PTS18-022
06-27-18

Subject: 25-39355-00 Head Gasket – Immediate Inspection & Return

Incorrect Gasket (V2003)

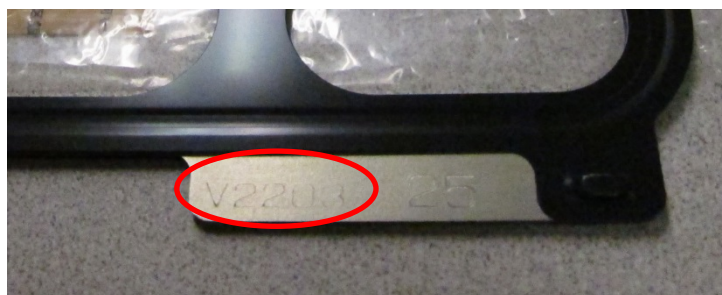
Carrier Transicold's Performance Parts Group has discovered that certain shipments of head gasket part number 25-39355-00 could have included an incorrect gasket in the package.

- The tab on the right side of the correct gasket will be marked with a V2203.
- If the gasket is marked with a V2003 or any number other than V2203, it is an incorrect gasket and needs to be returned to PPG.

Use of an incorrect gasket may, in certain circumstances, cause the head gasket to be damaged and/or fail, which could cause performance issues with the refrigeration unit engine.

Incorrect gaskets were discovered in packages labeled with a 028 date code; but PPG is requesting that dealers inspect all of their current stock and return affected inventory via the process outlined below.

1. Enter a Customer Inquiry on the *TransCentral*™ system for quantity being returned, using **"Incorrect Part Received"** category.
2. Return the affected gaskets to the following address – be sure to include RSO # in the top line:
